Edwin I. Hatch Nuclear Plant
Request to Implement an Alternative Source Term
Response to Request for Additional Information Regarding the
Unit 1 Main Steam Isolation Valve Alternate Leakage Treatment Path Evaluation

Enclosure: Response to Request for Additional Information regarding the Unit 1
Main Steam Isolation Valve Alternate Leakage Treatment Path Evaluation

Response to Request for Additional Information Regarding the
Unit 1 Main Steam Isolation Valve Alternate Leakage Treatment Path Evaluation

FIGURE 1:
SCHEMATIC OF LEAKAGE CONTROL PATH

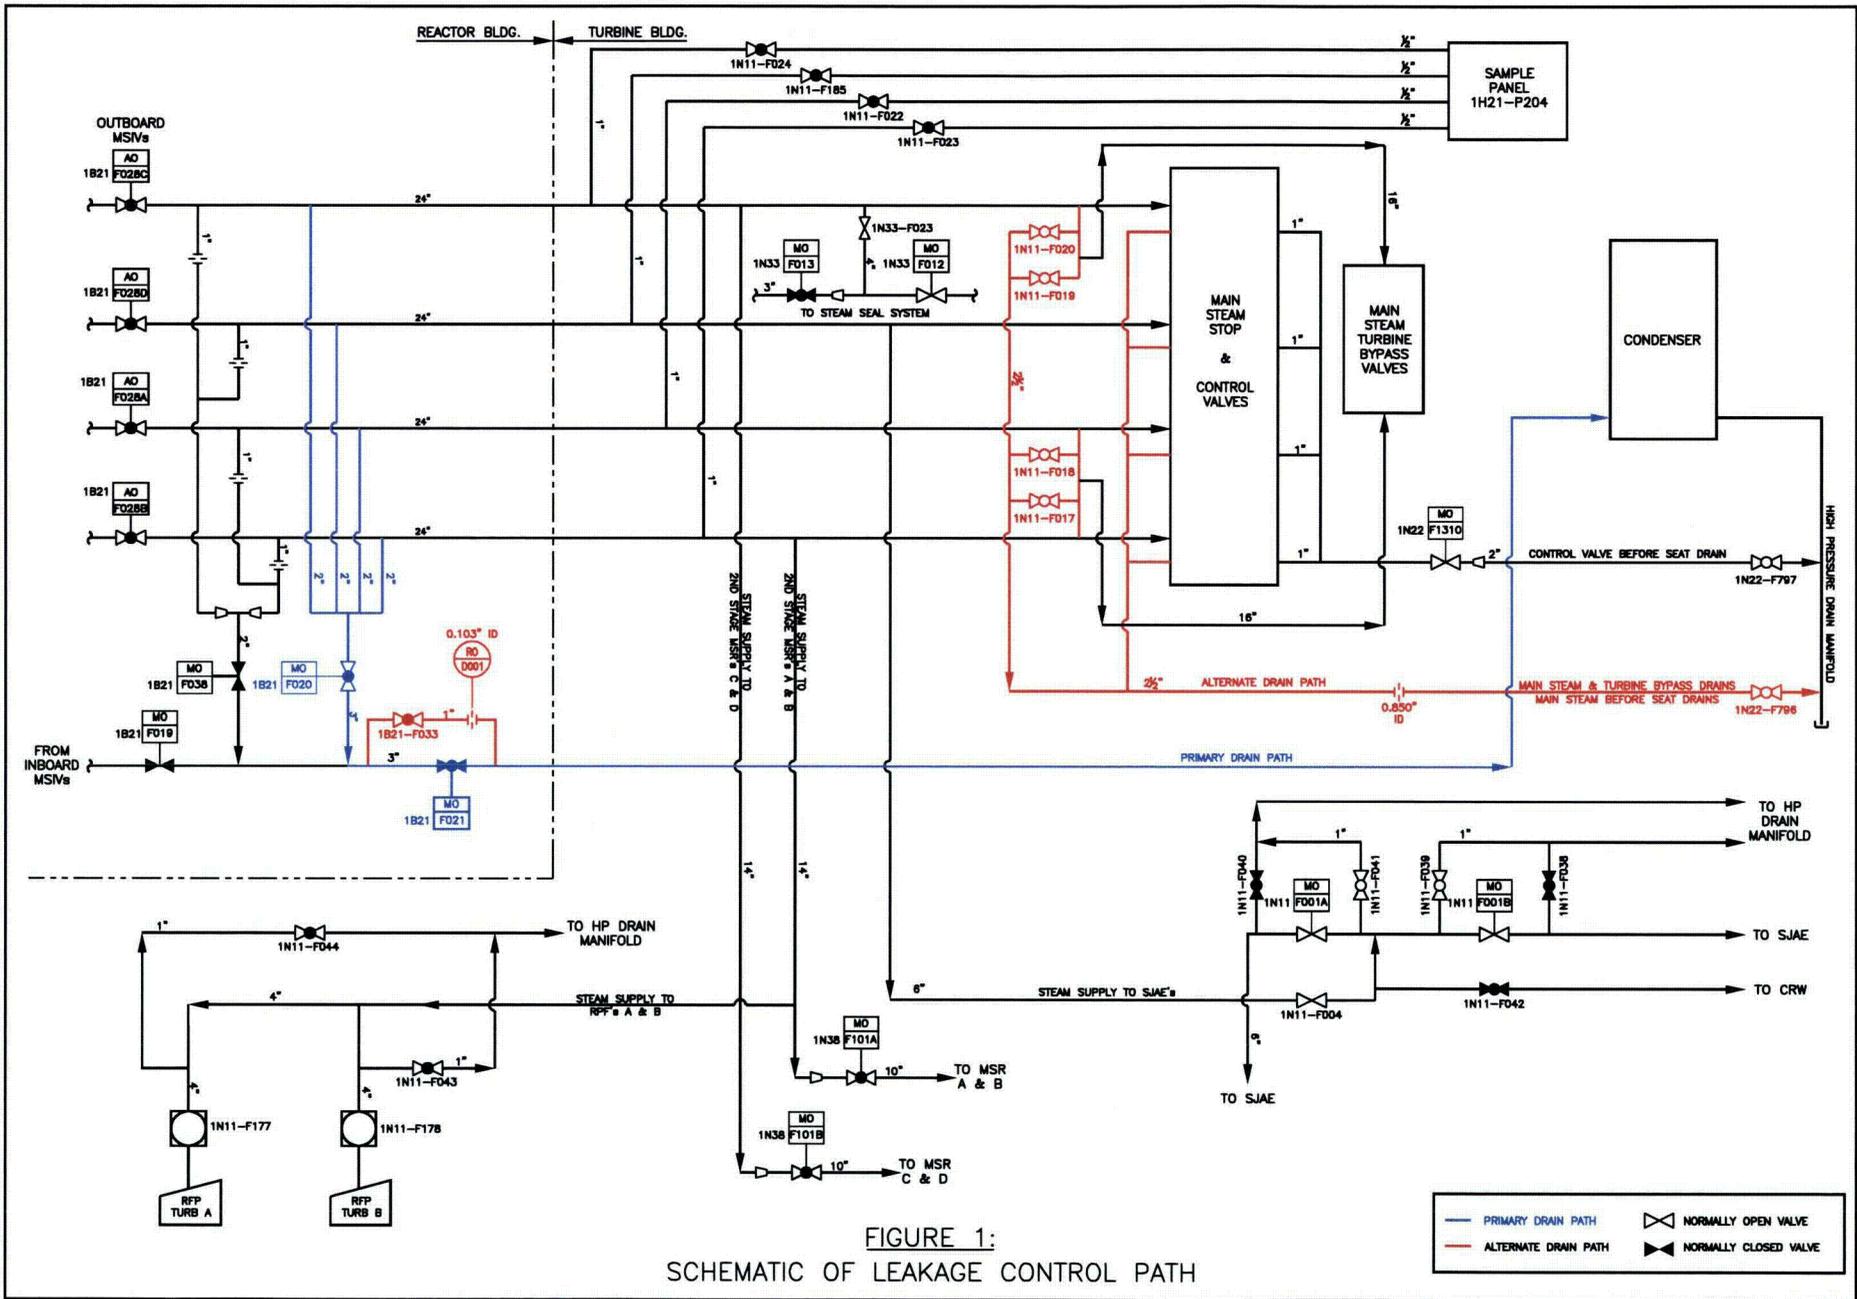
In the attachment, “Edwin I. Hatch Nuclear Plant Unit 1 Main Steam Isolation Valve Alternate Leakage Treatment (ALT) Path Description and Seismic Evaluation,” on page 1, of the above report information is provided to ensure that the ALT pathway boundary is isolated and that the release is via the condenser. When the list of valves that close automatically and those that require operator action to be closed is compared to Figure 1, “Schematic of the Alternate Leakage Treatment (ALT) Path,” a path still exists to “CRW” through valves 1N11-F004 and 1N11-F042.

- A. Please define the Acronym “CRW” as it is not defined in the submittal.
- B. Please provide justification for why provisions to isolate the potential release path to “CRW” are not provided.
- C. Please confirm that “Sample Panel 1H21-P204” provides an adequate boundary which can be relied upon in the event of a loss-of-coolant accident, and does not require additional isolation.

- A. CRW is the acronym for clean radwaste.
- B. The attachment referenced in this RAI was provided as enclosure 8 to the SNC alternative source term (AST) submittal dated August 29, 2006. The referenced page and figure provide a description of the Unit 1 MSIV ALT path. Due to an error on the referenced Figure 1, it appears that there exists a potential release path to CRW. Specifically, valve 1N11-F042, a 1-inch manual valve in a drain line off the steam line, is normally closed; it was inadvertently shown as open on Figure 1. A revised Figure 1 correctly showing 1N11-F042 as normally closed is provided to replace the Figure 1 previously provided in both enclosures 1 and 8 of the AST submittal. Valve 1N11-F004 is a 6-inch manual gate valve in the steam line to the steam jet air ejectors (SJAE) and is correctly shown in Figure 1 as normally open. Therefore, the potential release path to CRW is properly isolated by the normally closed valve 1N11-F042.

Sample panel 1H21-P204, as shown in the previously referenced Figure 1, is located in the water analysis room in the control building. It is the sample hood at which grab samples are taken. The sample panel was labeled as 1H21-P204 on Figure 1 for diagrammatical purposes. Sample lines from the main steam lines are routed to the water analysis room where the lines split and initially enter sample panels 1H21-P205 and 1H21-P206. There is a normally closed sample inlet valve for each line within 1H21-P205 and 1H21-P206. These closed manual valves are the ALT path boundary valves for these lines. Operator action is required to open these valves to establish sample flow. Samples from 1H21-P205 are then routed to sample hood 1H21-P204 for grab samples and samples from 1H21-P206 go to analyzers on panel 1H21-P208.

Based on the information discussed here and in the previously referenced enclosure 8, the normally closed manual valves mounted in the sample panels provide an adequate boundary which can be relied upon in the event of a LOCA, and does not require additional isolation.
